AMENDMENT OF SOLICITATION

1. AMENDMENT/MODIFICATION NO <b>0003</b>		2. EFFECTIVE DATE <b>MARCH 25, 2003</b>	
3. ISSUED BY  DEPARTMENT OF THE ARMY, BALTIMORE DISTRICT CORPS OF ENGINEERS P.O. BOX 1715 BALTIMORE, MARYLAND 21203-1715

6. ACCOUNTING AND APPROPRIATION DATA (If required)  <b>COMMUNITY SUPPORT CENTER FORT DETRICK, MARYLAND</b>			
7. DESCRIPTION OF AMENDMENT/MODIFICATION (Organized by UCF section headings, including solicitation/contract subject matter where feasible.)  <p style="text-align: center;"><b>SEE THE FOLLOWING PAGES</b></p>			
Except as provided herein, all terms and conditions of the document referenced in Item 4A, as heretofore changed, remains unchanged and in full force.

d) Lintels for New Openings in Existing Walls:

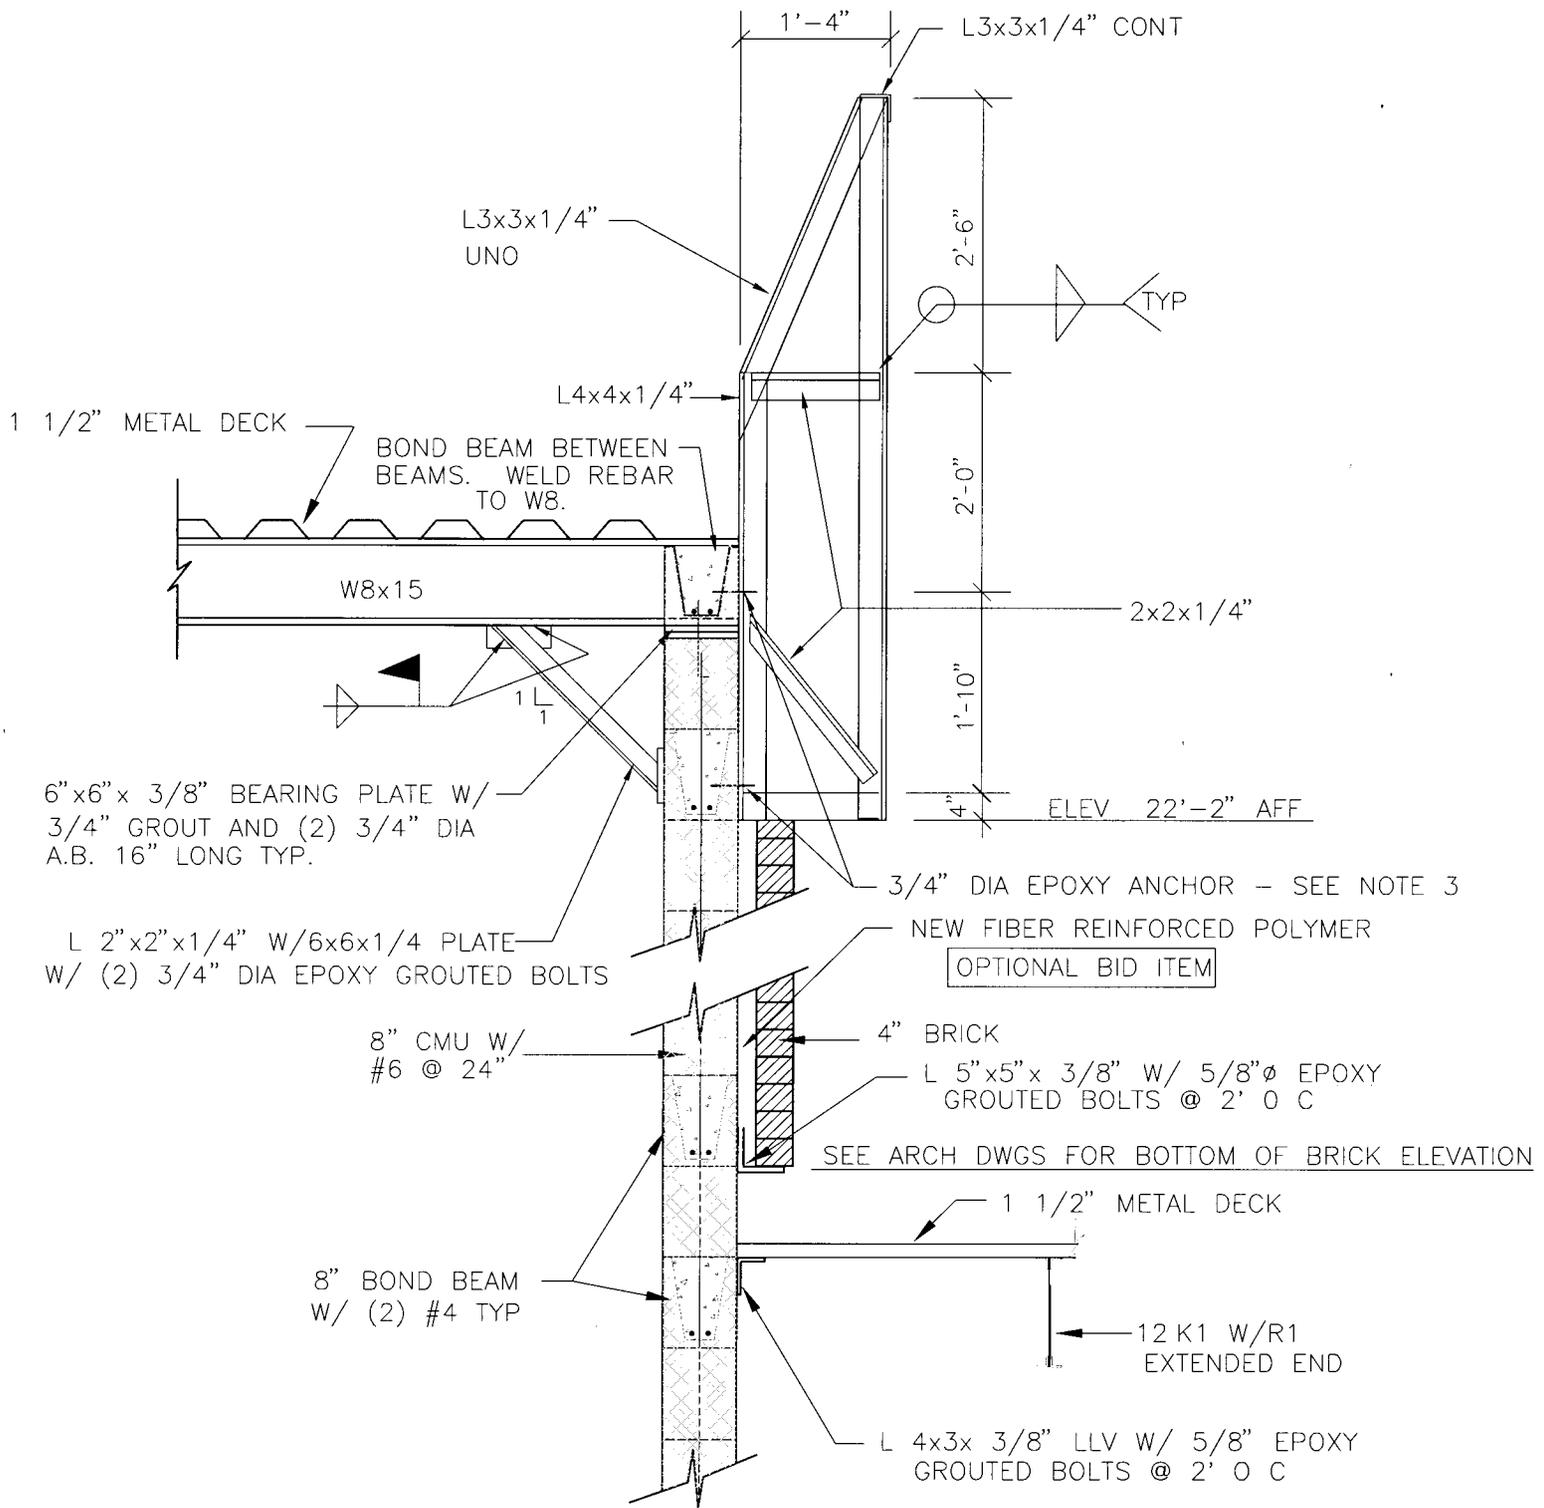
- 1) Revise note to read: Use for openings less than 4'-8"
- 2) Delete lintel for second floor mechanical room door.

SKETCH S-1 20 MARCH 2003

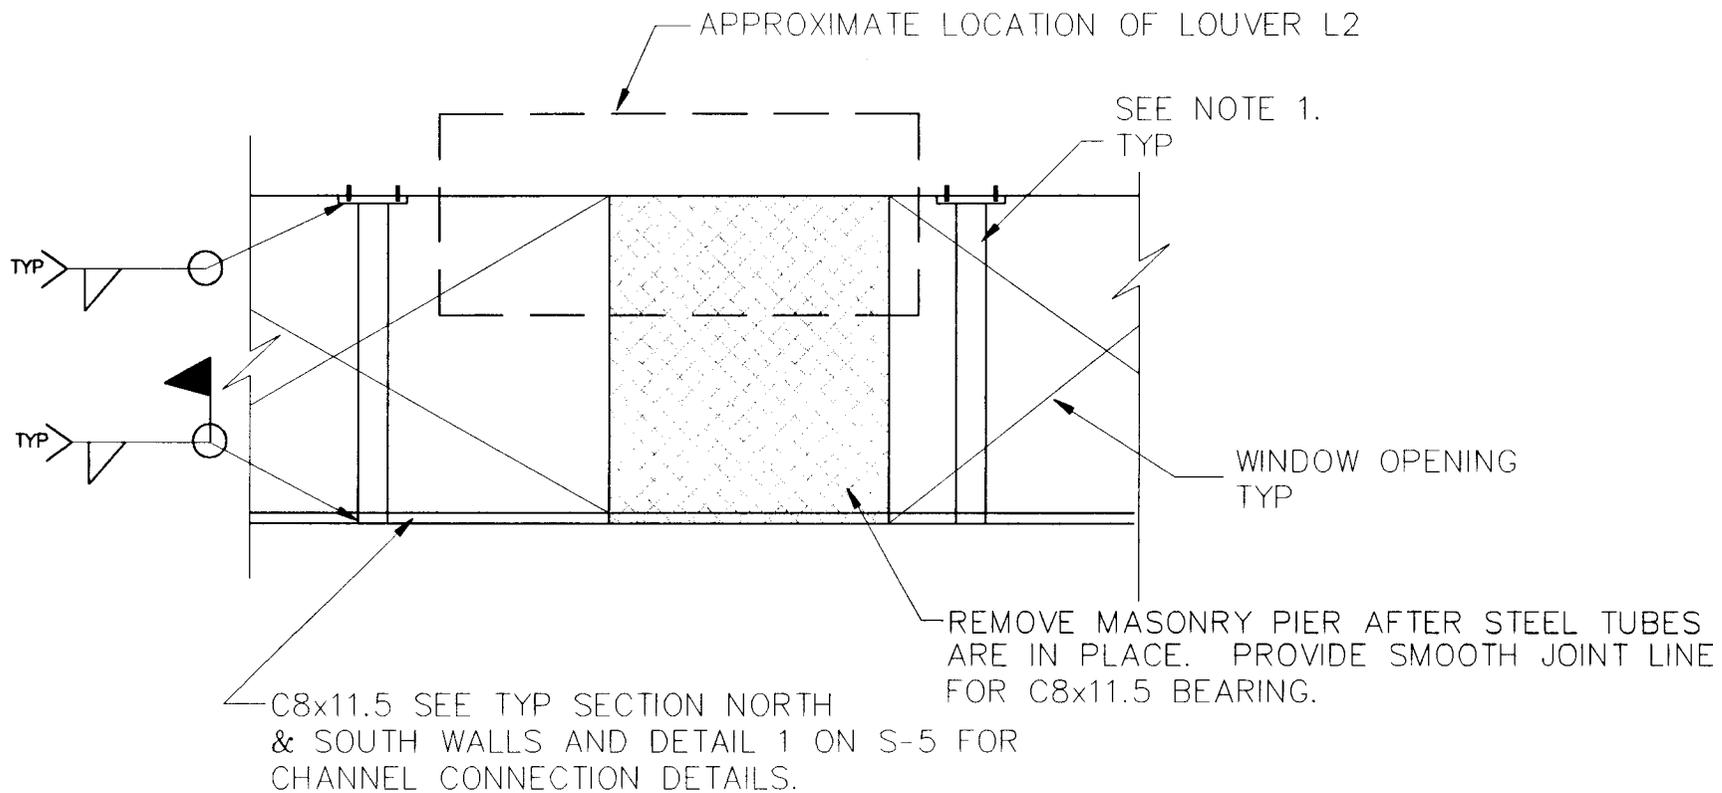
b) Section A/S-1/S-3: Delete this detail as shown and substitute therefor the attached Sketch S-1 dated 21 Mar 2003.

COMMUNITY SUPPORT CENTER  
 FT. DETRICK, MD  
 SKETCH S-2 21 MAR 2003

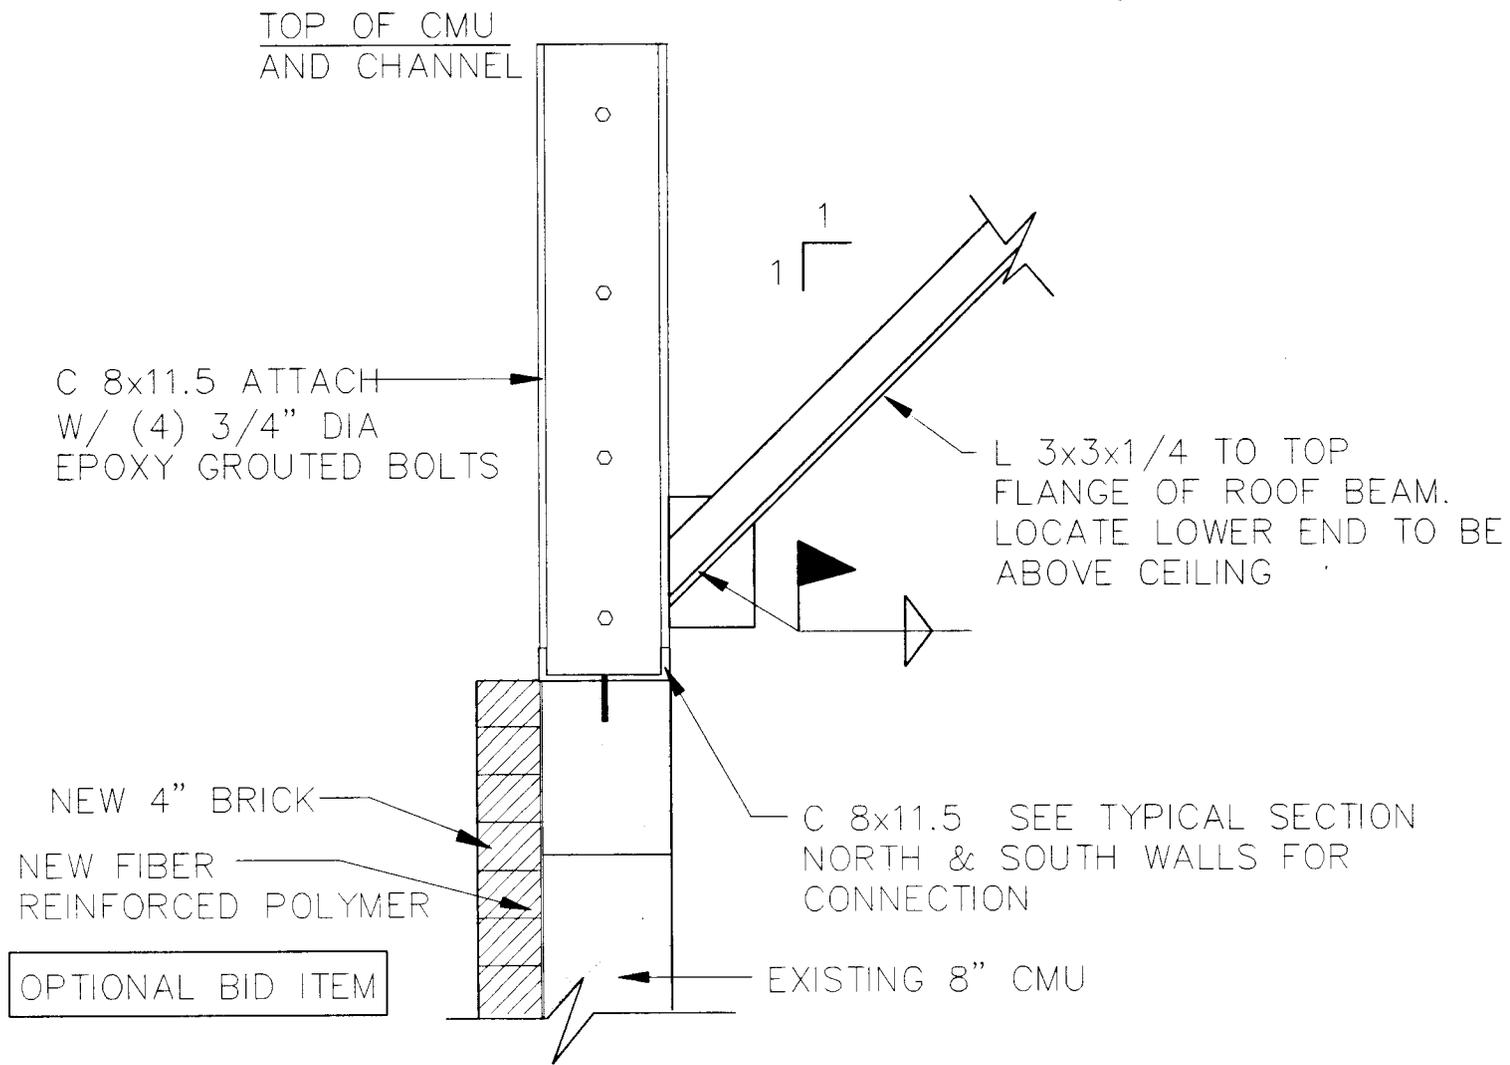
23) Sheet S-6: Add attached Sketches S-2 and S-4 dated 21 Mar 2003 to this sheet.

COMMUNITY SUPPORT CENTER  
FORT DETRICK, MD  
SKETCH S-3 21 MARCH 2003

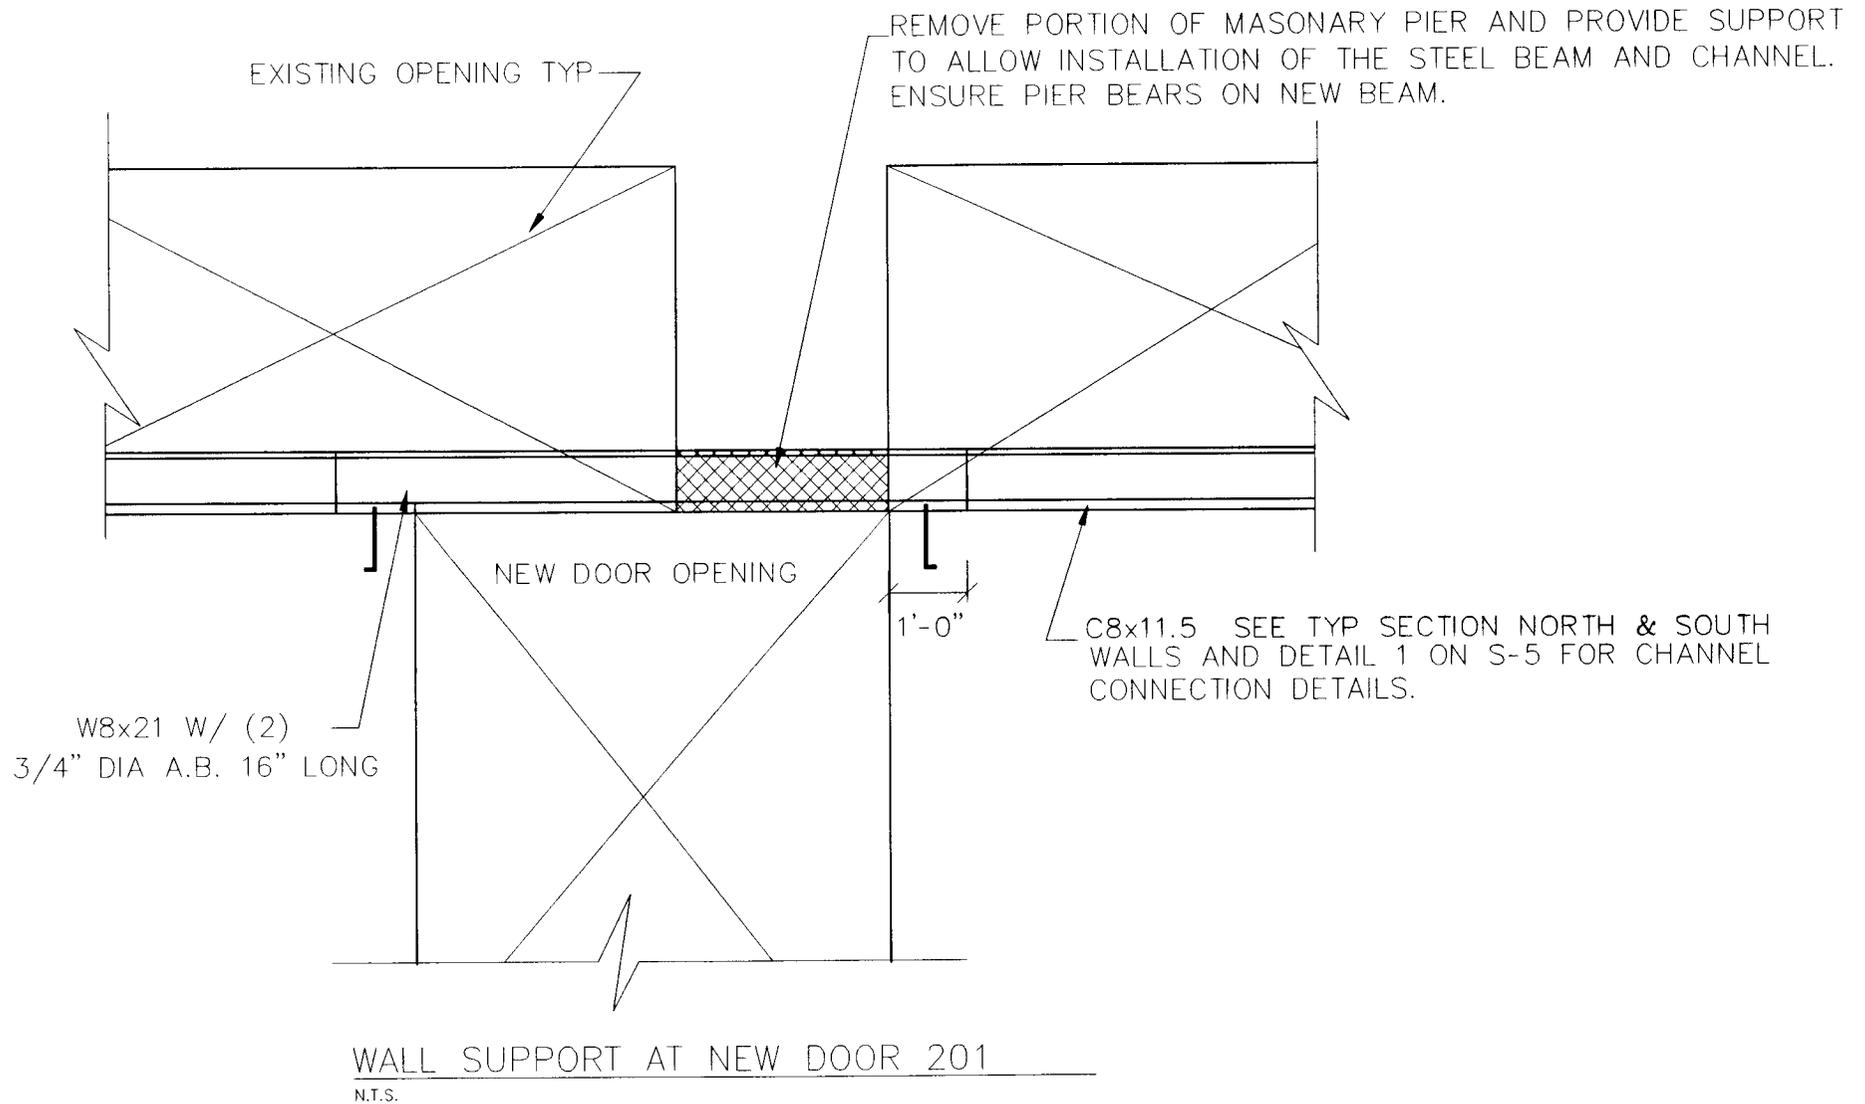
a) General: Add Sketch S-3 dated 21 Mar 2003 to this sheet.

b) Typical Section North and South Walls: Add the following note to channel connection to column: "See detail 1/S-5 for channel connection at end of wall where masonry extends above channel."
